本處檔號 OUR REF. (24) in FP(FS) 314/07 II

13 May 2008

FSD Circular Letter No. 5/2008
Graphical Symbol Exit Signs

Figure 3 – Graphical Symbol Exit Sign

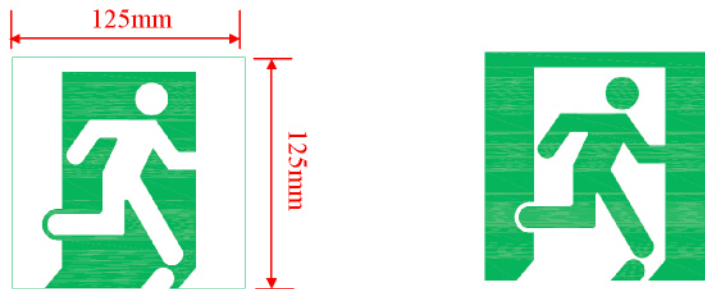
- (c) Graphical Symbol Exit Sign (Figure 3)
- In this design, it is only a graphical symbol of not less than 125mm x 125mm. Figure 4 shows the details of the symbol.

Figure 4 – Detailed Scale of the Graphical Symbol

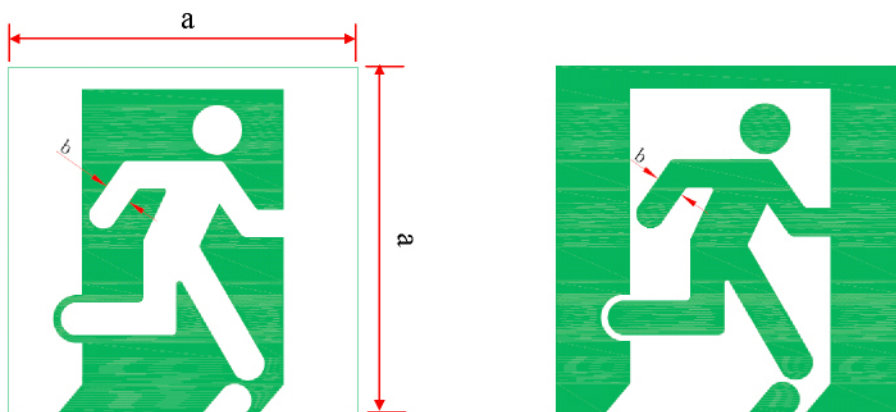
(Dimension: $a \geq 125\text{mm}$ and $b \geq 10\text{mm}$)
